**CITY OF VANCOUVER
PLANNING & DEVELOPMENT SERVICES**

**DEVELOPMENT PERMIT STAFF COMMITTEE
MEETING
October 30, 2019**

**1503 Kingsway (COMPLETE APPLICATION)
DP-2018-00892 – C2**

Figure 9: Anticipated Height Reduction – Kingsway

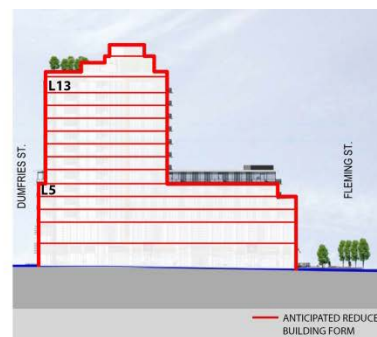
Nevertheless, to reduce the appearance of an imposing and bulky massing and to augment integration within the Kingsway streetscape, staff are seeking a reduction in the podium height under Recommended Condition 1.1 (see figures 8 and 9).

- 1.1 design development to reduce building height to more closely achieve the performance of the C-2 zone;

Note to Applicant: The intent of this condition is to minimize the impacts with regards to the additional height and larger massing, to enhance the contextual fit and better integrate the development with the streetscape, to reduce the building bulk and to address the excess of floor area. Height must be reduced from the podium of the mixed-use building by deleting, at minimum, one storey and set back the fifth storey 2.4 m. Refer to Standard Condition A.1.14.
